International Aero Engines
SERVICE BULLETIN

Subject: Transmittal of Revision 2 to Service Bulletin V2500-ENG-71-0182.

POWER PLANT - EEC CHANNEL-A AND B HARNESSSES (LOOM A AND B) - INTRODUCTION OF
REVISED ENGINE DEDICATED ALTERNATOR CONNECTORS

V2500-ENG-71-0182

Schematic view of harness Loom-A - Bottom of engine
Figure 2

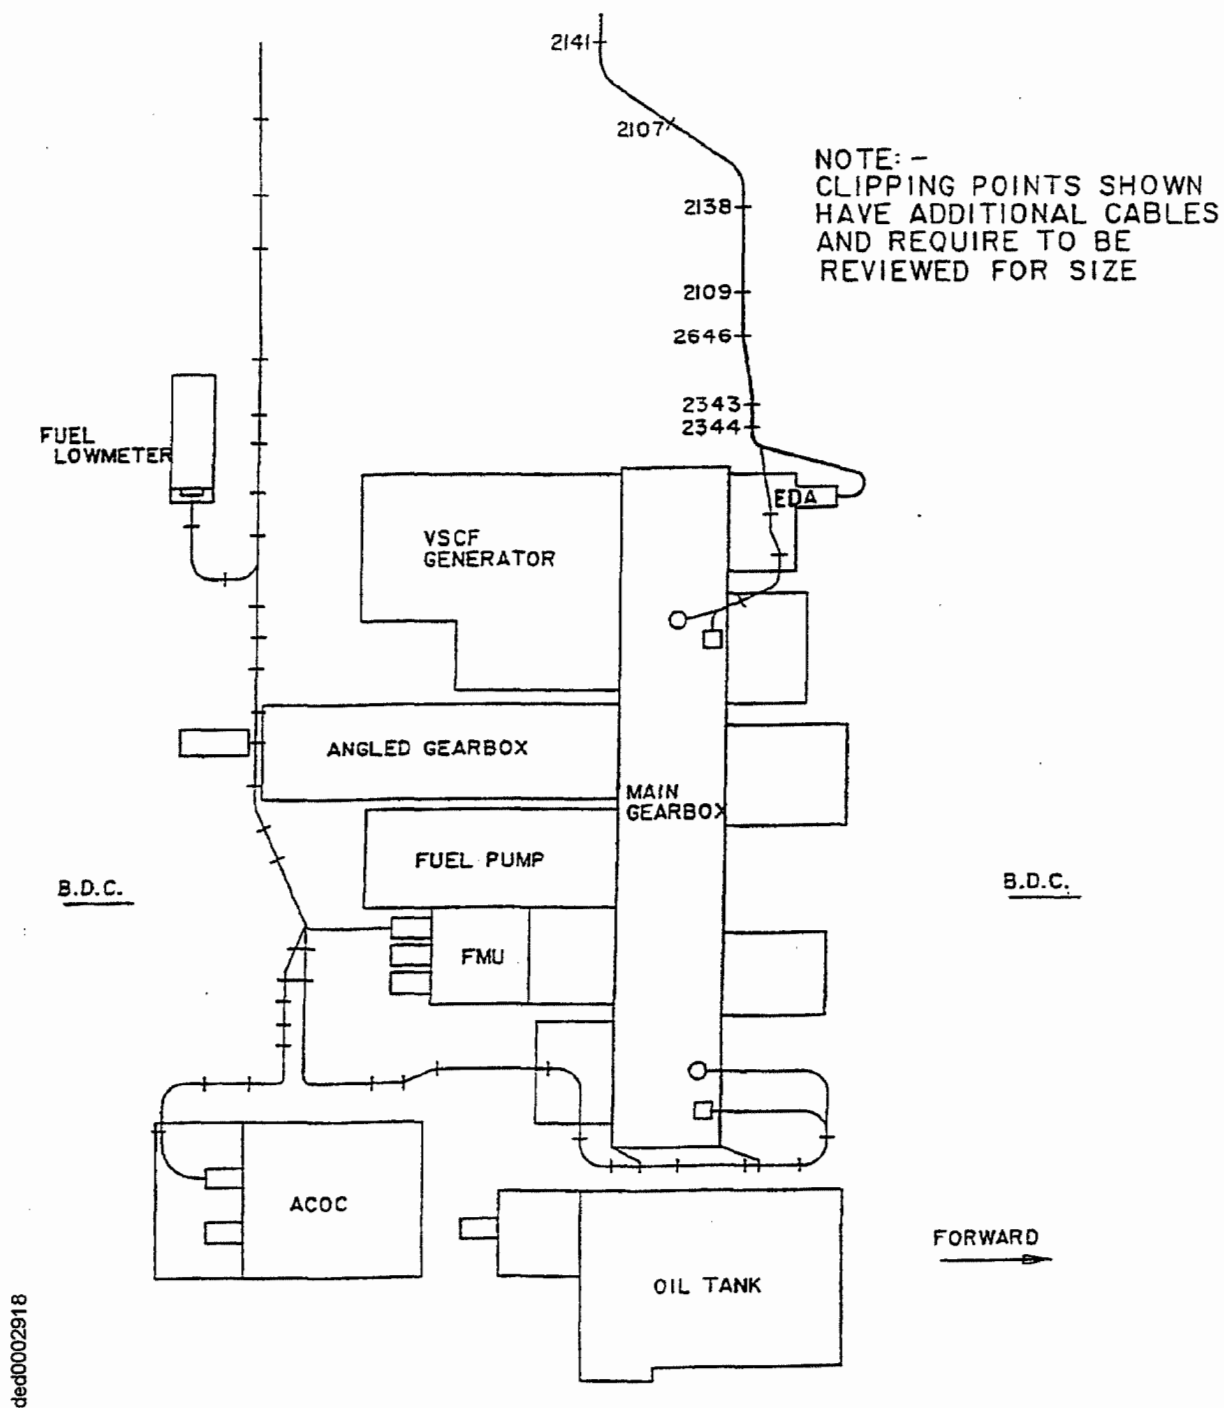
- R (5) For Loom-A install cable assembly 6A6526 to EDA receptacle A. From connector
PI-8024 face to CP2344, the length should be 300,0 mm. (Refer to Figure 2).

- R (8) Install the new leads. All the new harness cables should be clipped through CP2344 and CP2343,
R then clipped and tied with the harness through CP2646 to CP2278. (Refer to Figures 2 and 3).

Schematic view of harness Loom-A - Top of engine
Figure 3

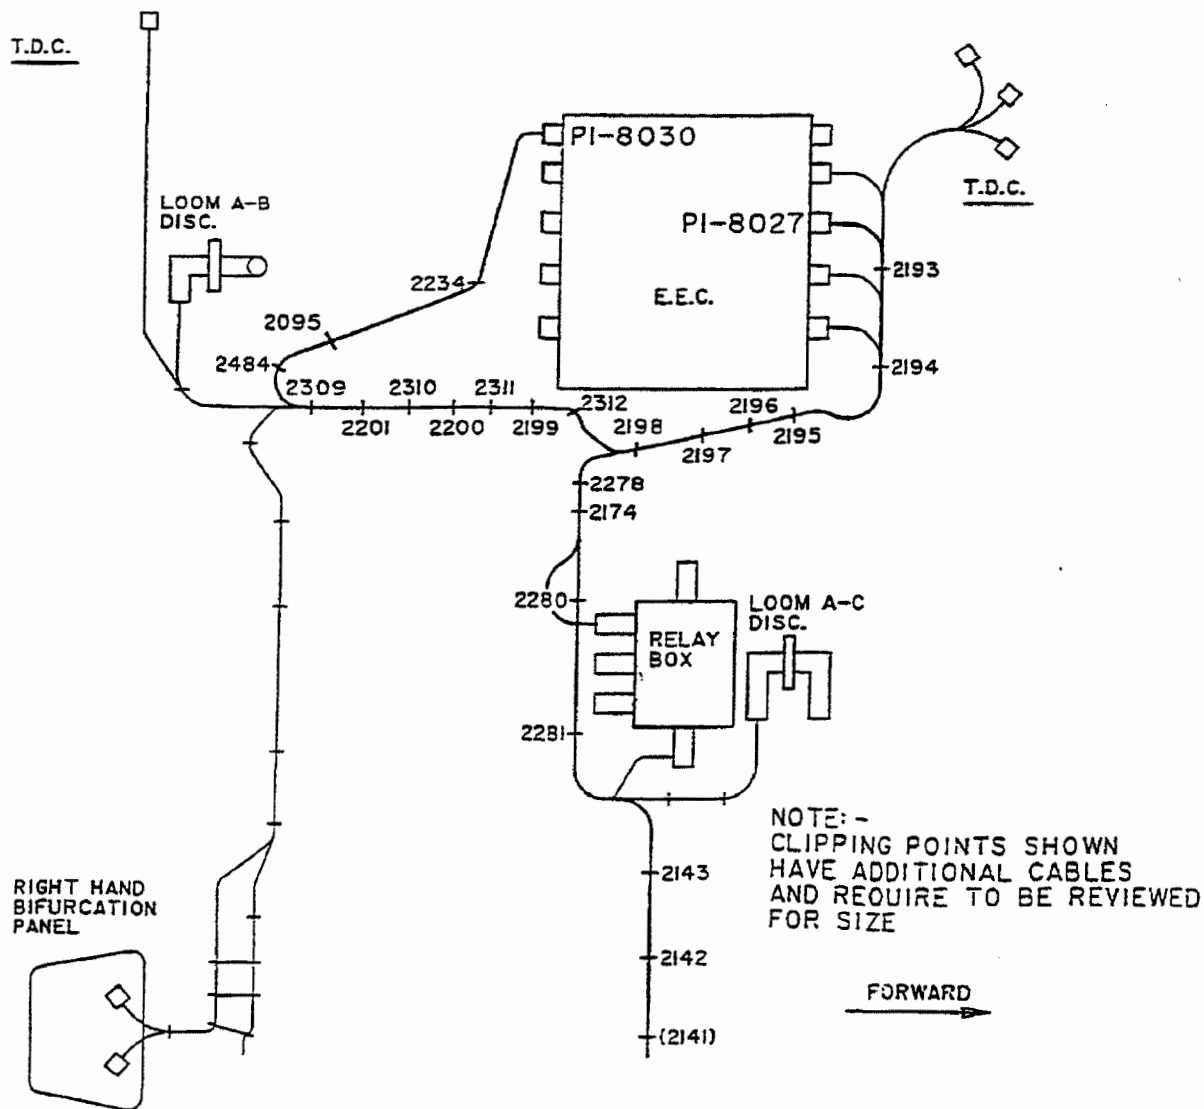
- R (5) With the IAE IJ12018 EEC Harness wrench, disconnect the electrical connectors PI-8027 and
R PI-8030 from the EEC. (Refer to Figure 3).
- R (6) To remove the PI-8024 connector, cut the EEC fan harness 1.299 in. (33,00 mm) from clipping
R position CP2646. (Refer to Figure 4).

- R (10) One cable pair, ident 6A068B20 to be clipped and tied through CP2198 to CP2193 for EEC
R connector PI-8027. The other three cable pairs, ident 6A057B20, 6A058B20 and 6A059B20
R to be clipped and tied through CP2312 to CP2234 for EEC connector PI-8030. (Refer to Figures
R 3 and 5). The distance between harness ties made from 3100631 lacing tape (White), must be no
R more than 1.97 in. (50,0 mm). (Refer to Figures 5 and 6).

- (13) Assemble the remaining clipping points. Torque load the nuts to between 36 and 45 lbfin. (4,0 and 5,0 Nm). (Refer to Figure 3).

Schematic view - Rework of Loom-A
Figure 4

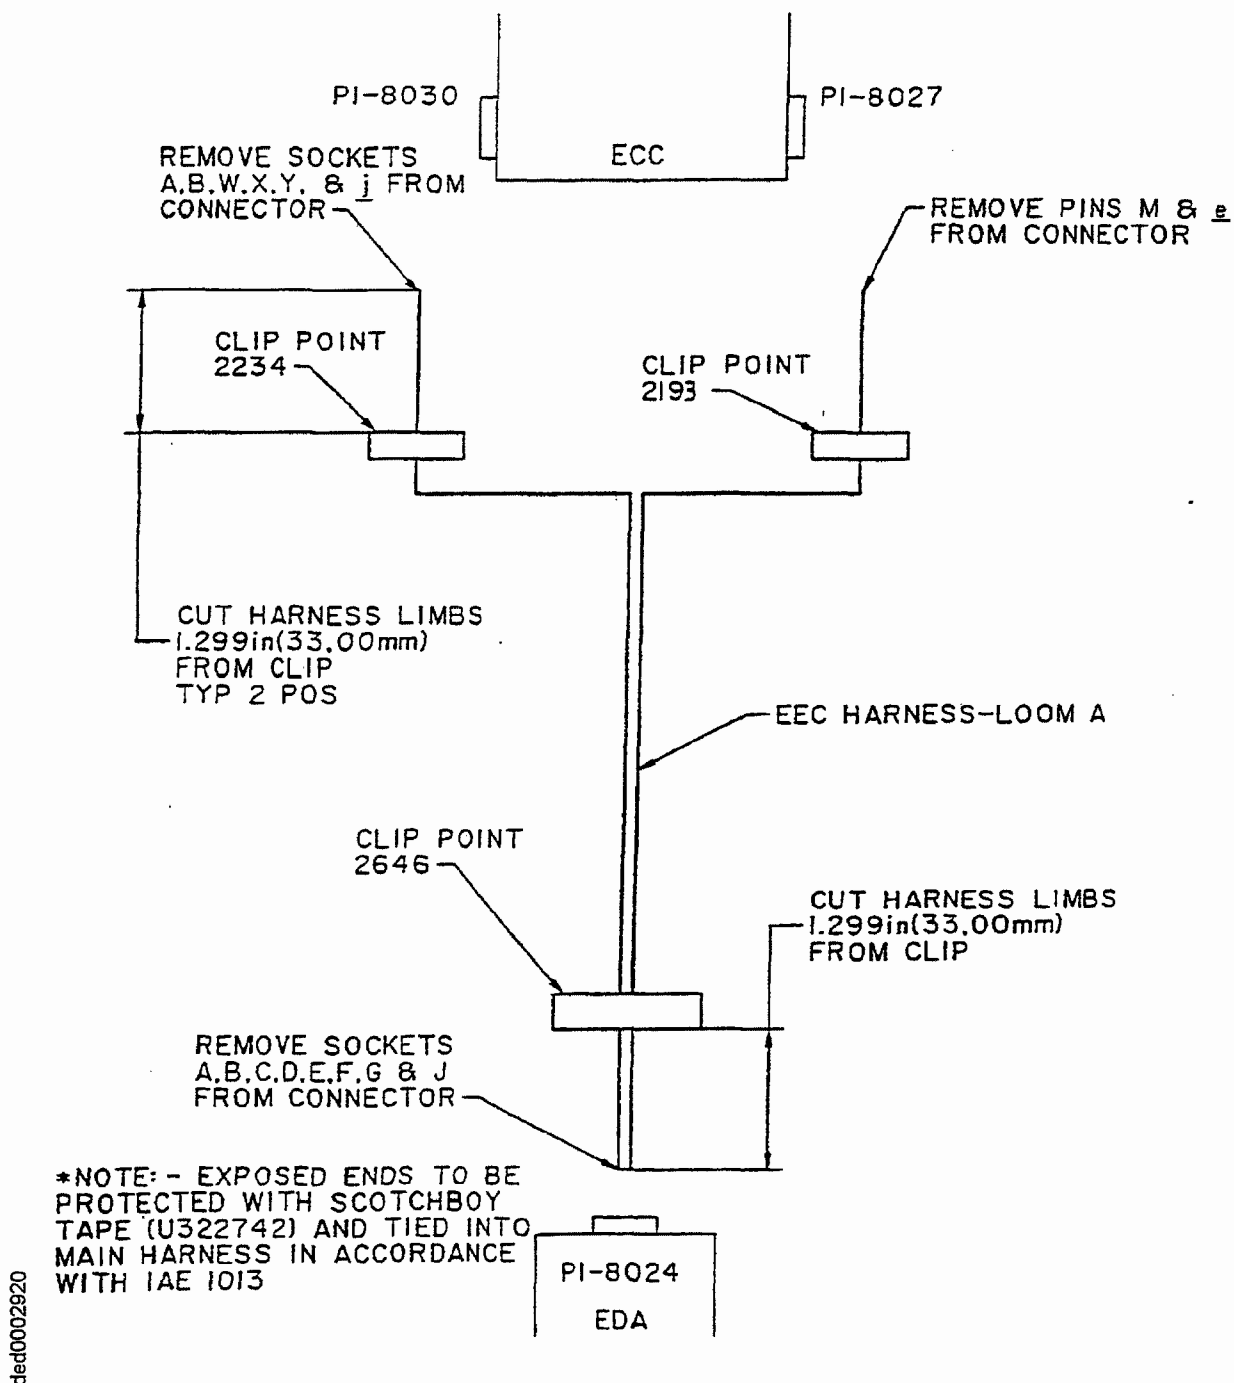
| (b) Remove two contacts from connector PI-8027. | Identify pins M and e in the connector.
| (c) Cut off the two contacts 1.299 in. (33,00 mm) from clipping position CP2193. Make sure the identification sleeves remain attached to the harness. | Use standard workshop equipment
| (f) Remove the six contacts from connector PI-8030. | Identify sockets A, B, W, X, Y, and j in the connector.
| (g) Cut off the six contacts 1.299 in. (33,00 mm) from clipping position CP2234. Make sure that the identification sleeves stay attached to the harness. | Use standard workshop equipment.

Wiring diagram - Loom-A - After alteration
Figure 5

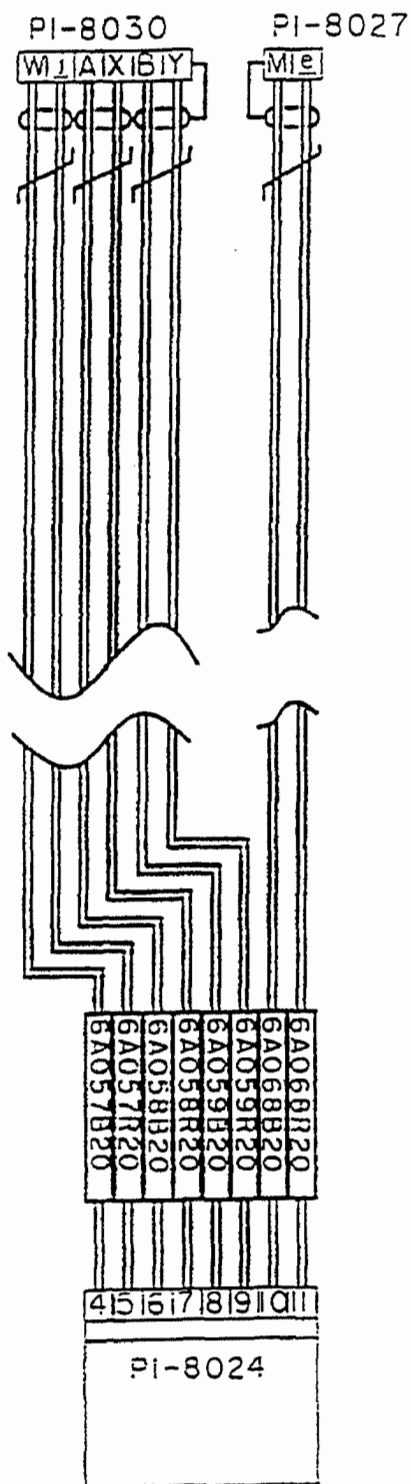
- (c) For harness connector PI-8027, install the contacts at positions M and e of the new leads.
For harness connector PI-8030, install the sockets at positions A, B, W, X, Y and j.

- (f) Identify the wires and loom connections on the new leads at positions PI-8027 and PI-8030. (Refer to Figure 5).

- (12) With the IAE IJ12018 EEC Harness Wrench, connect the PI-8027 and PI-8030 electrical connectors to the EEC Fan harness and torque load them to 32 lbfin. (3,6 Nm). (Refer to Figure 5).

Installation of lacing ties to harness
Figure 6

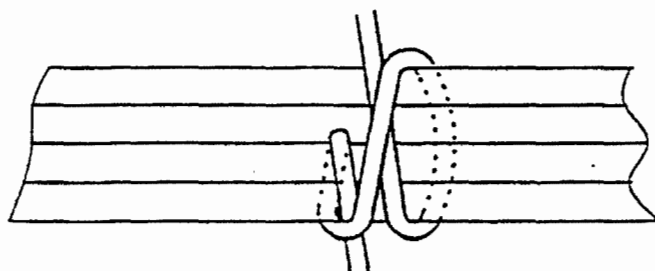
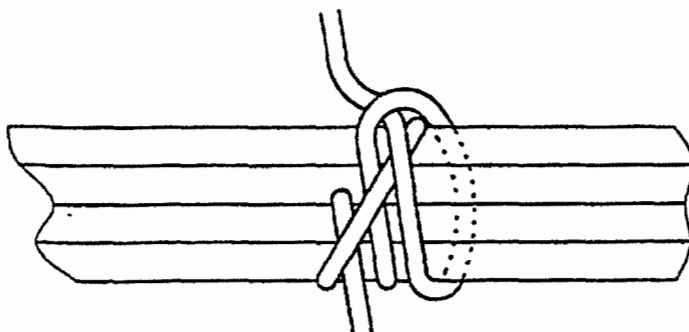
| (e) Tie back the cut ends to the existing EEC fan harness. Make sure that the identification sleeves can still be read. | Use 310063 lacing (White tape) as necessary.
| (i) Tie back the cut ends to the existing EEC fan harness. Make sure that the identification sleeves can still be read. | Use 310063 lacing (White tape) as necessary.

Wiring diagram - Loom-B - New connections
Figure 7

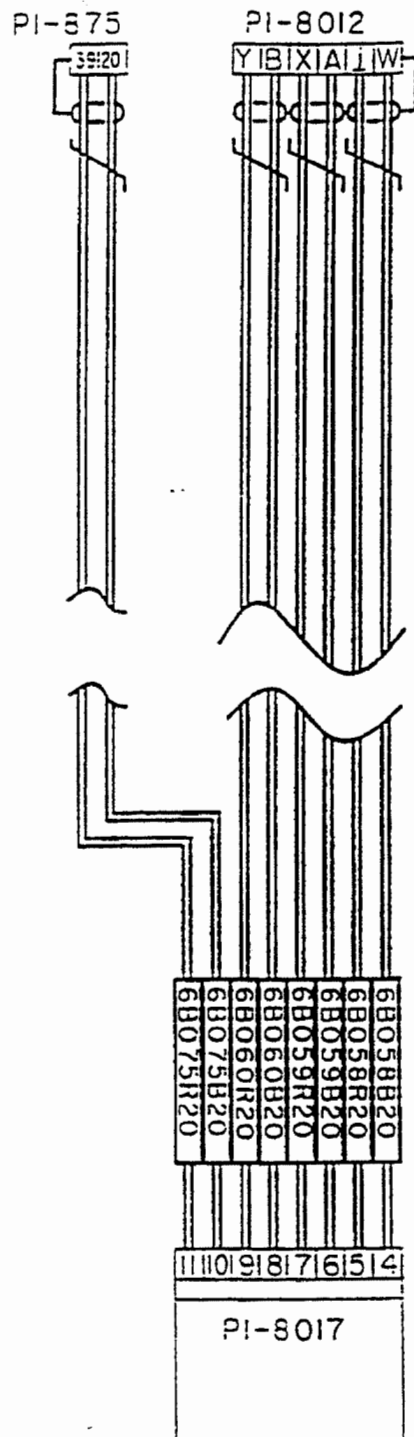
- (h) Move the existing wire identifications back along Loom-B so that they are less than 14.0 in. (355,6 mm) from CP2346. Alternatively, identify the wires and loom connections of the new leads at the EDA PI-8017.
(Refer to Figure 7).

| | (l) Install the contact sockets to connector PI-8017. (ESC 10SE61212S60 and ESC 65E12 Backshell). | Use a crimping tool. (Daniels M2252011-02 or equivalent. (Refer to Figure 7). |

Schematic view - Part of Loom-B - After alteration
Figure 9

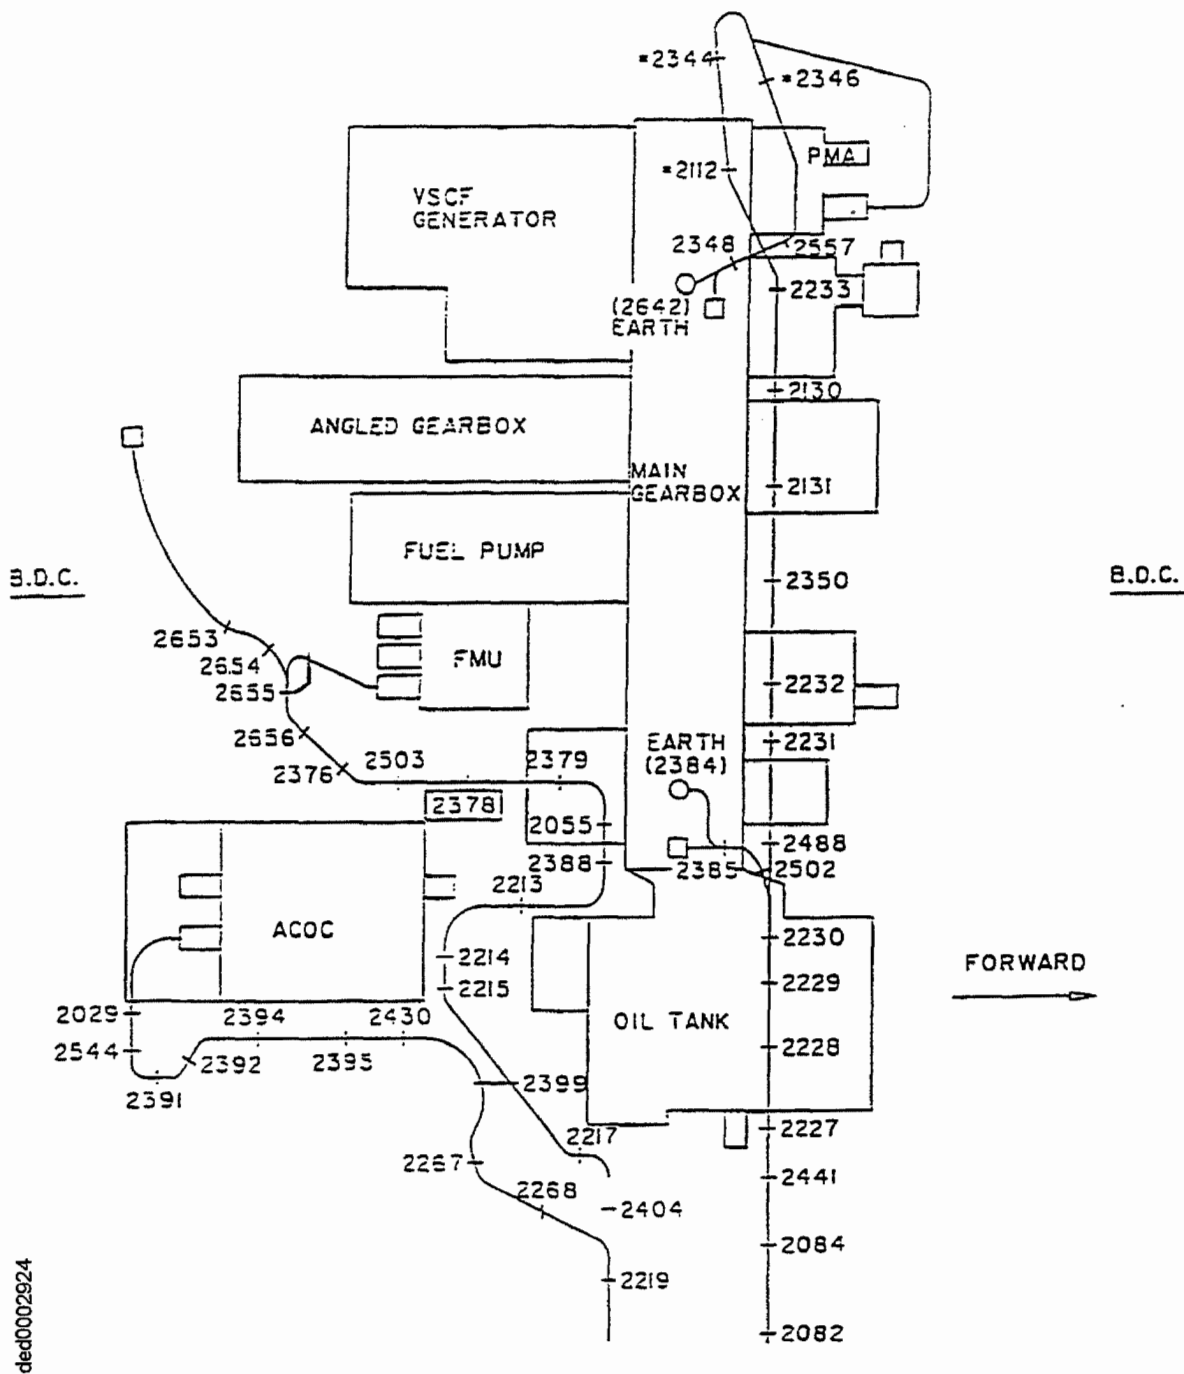
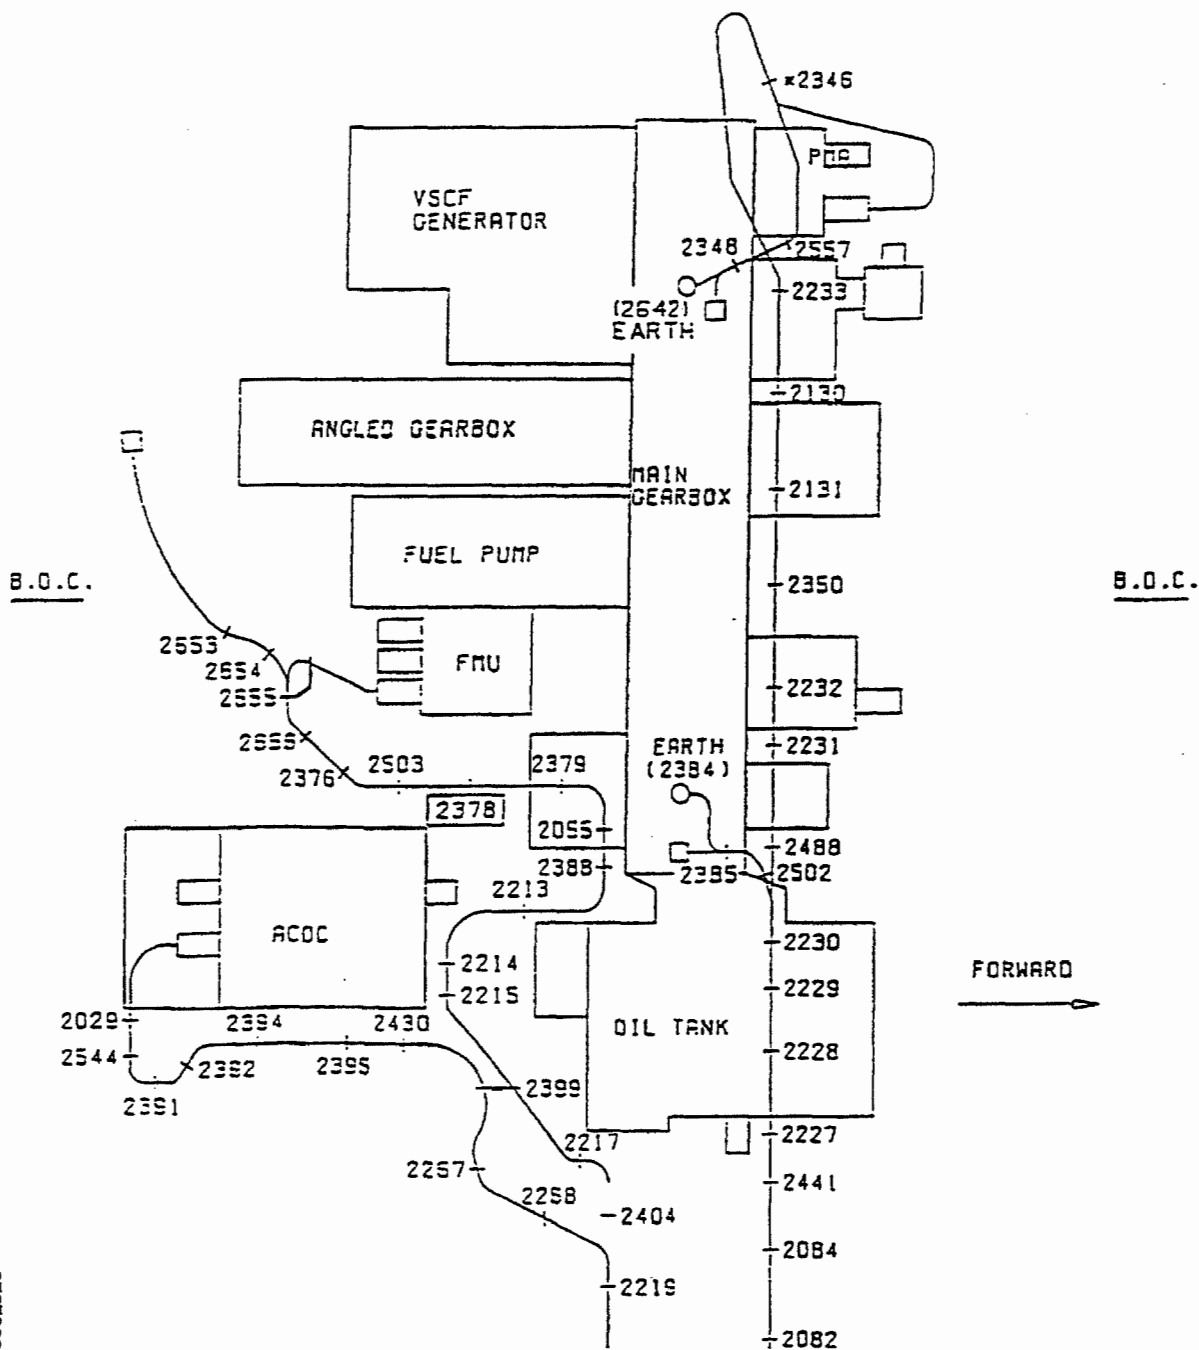
- R (iii) The sealing plugs have been revised to match the revised connector and the quantity is
R increased from two to four.
- R (iv) The backshell at PI-8017 has been revised. The shape of the backshell has been changed
R from right-angled to straight.

- (d) Clip positions CP2684 and CP2112 are deleted.
- (e) Clip positions CP2344 and CP2346 are revised.
- (2) The existing EEC harness assemblies (Looms A and B) can be reworked. (Refer to Figures 1 to 11).
